# **28F016XD**

## **SPECIFICATION UPDATE**

Order Number 297555-008

### Operation Delay after Power-Up and Exit from Power-Down or Reset

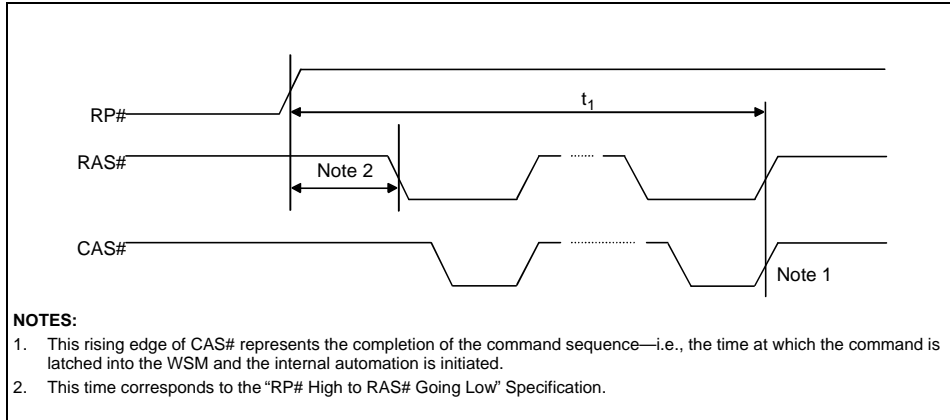
**PROBLEM:** With the program/erase voltage ( $V_{PP}$ ) at 5V, the internal  $V_{PP}$  detector may not stabilize for up to 5  $\mu$ s (illustrated by  $t_1$  in the figure, *Operation Delay after Power-Up and Exit from Power-Down or Reset*, which follows) after RP# transitions inactive (high). This causes an invalid  $V_{PP}$  Level bit indication when reading the Block Status Registers and termination of program, erase or lock block operations due to invalid device  $V_{PP}$  error detection. Affected operations include Word Write (40H/10H), Block Erase (20H) and Lock Block (77H).

**IMPLICATION:** 5V  $V_{PP}$  power-up/reset time delay to first program or erase operation is impacted.

**WORKAROUND:** Upon reset, power-up, or wake-up from software sleep or hardware deep power-down, allow 5  $\mu$ s ( $t_1$ ) before initiating a Write/Erase command (as listed earlier) or reading the  $V_{PP}$  Level bit of the Block Status Registers (BSR.1). The figure below illustrates this timing requirement ( $t_1$ ) in more detail.

Operations are initiated by the device on the rising (trailing) edge of the last CAS# pulse in the command sequence. Two-cycle command operations such as Word Write or Erase are initiated on the rising edge of the CAS# pulse corresponding to the Address/Data or Confirm command.

**Example System Software Flowchart That Will Not Encounter “Completion with Command Error” Condition**

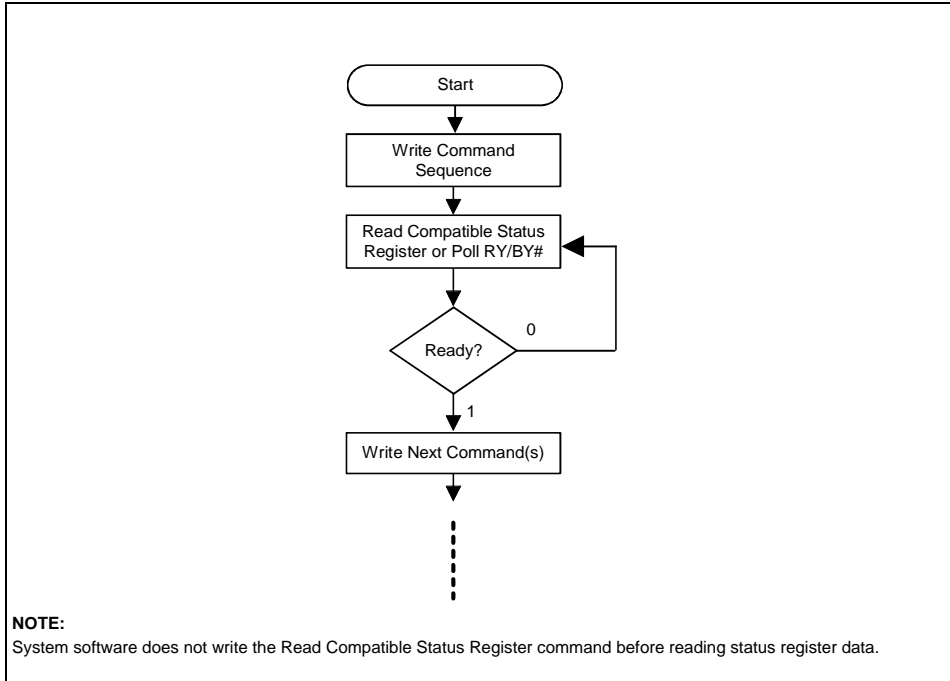
**PROBLEM:** Systems in which software, after initiating device automation, writes another command(s) to the device before automation completes may initiate unintended device operations.

These unintended operations will produce an invalid command error indication. A command error is indicated by a “1” in the following Status Register bits:

Systems that poll the RY/BY# pin or WSMS bit (CSR.7) for “Ready” indication before writing another command to the device will not encounter this erratum. This is illustrated in the *Example System Software Flowchart, etc. figure* (which follows), and flowcharts 11-1 and 11-2 (without erase suspend) of the *16-Mbit Flash Memory Product Family User’s Manual*.

**Timing Waveform Showing Specification Ranges That Will Not Cause the “Completion with Command Error” Condition**

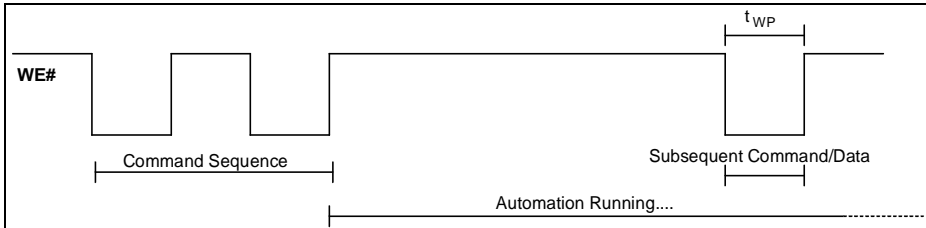
A WE# pulse width defined by the ranges of parameter  $t_{WP}$  in the following table will result in a system that does not exhibit this erratum. (Note: timings are also bounded by specifications in the device datasheet.)

V <sub>CC</sub> Supply Voltage	$t_{WP}$
5V	<75 ns
3.3V	<100 ns

**Erase Suspend to Read Array with Compatible Status Register**

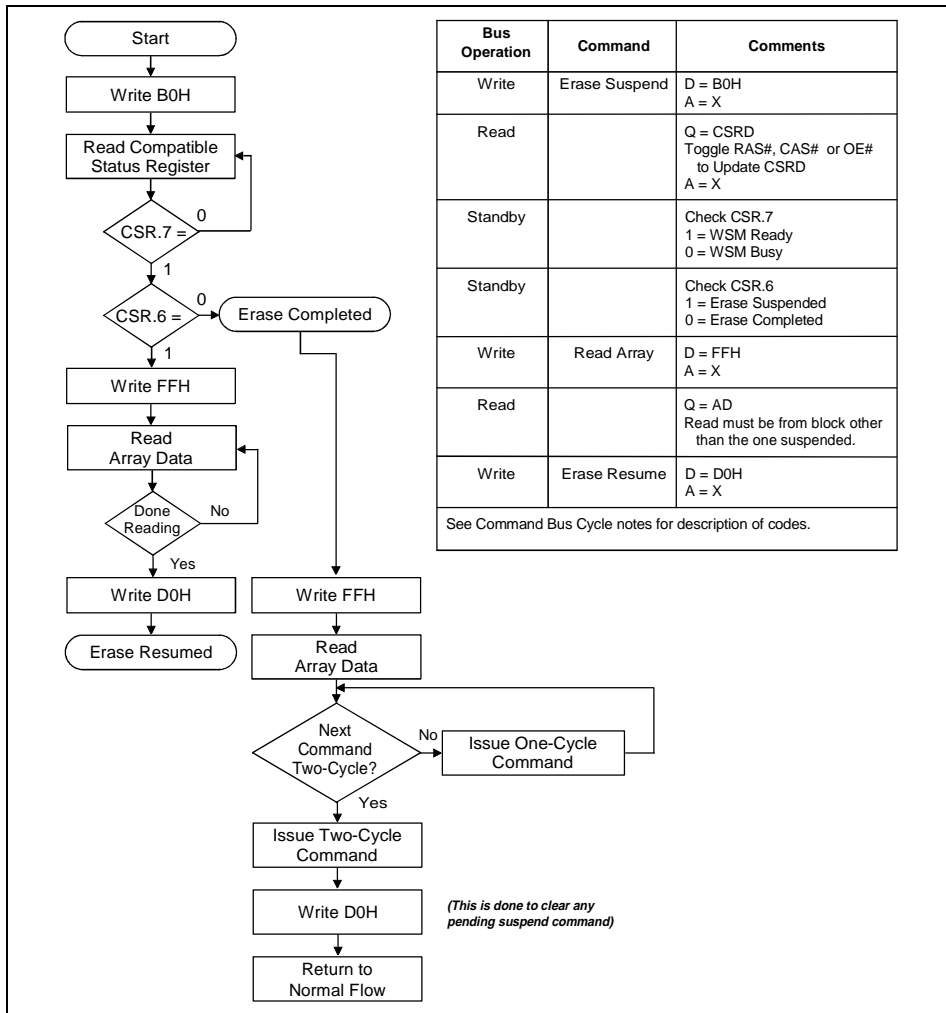
**PROBLEM:** If an Erase Suspend command is issued late in the Erase algorithm, it will not be recognized by 28F016XD components listed in the Affected Devices section, and erase will complete. This Erase Suspend command will **not** be discarded.

- A. If another Erase command is issued at some time later, the device then assumes that the pending Suspend request is still valid and will automatically Suspend the current Erase.
- B. If any queueable command is in the command queue waiting for execution while another queueable command is in progress, the Write State Machine will suspend its operation after completing the current command. (Refer to *the 16-Mbit Flash Product Family User's Manual*, Section 11-1 for the queueable command list.)

**WORKAROUND:** A software workaround to this erratum inserts a redundant Resume command (D0H) immediately following any Two-Cycle Command (Word Write, Block Erase, Lock Block, or Upload Status Bits) in the Erase Suspend flowcharts. Modified Erase Suspend to Read Array flowcharts (Figures 11-3 and 11-12 of the *16-Mbit Flash Memory Product Family User's Manual*) detailing this workaround are shown in the *Erase Suspend to Read Array with Compatible Status Register* and *Erase Suspend to Read Array with Extended Status Register* figures, which follow. This erratum results in the *Erase Suspend with Compatible Status Register* flowchart being incompatible with the 28F008SA *Erase Suspend* flowchart.
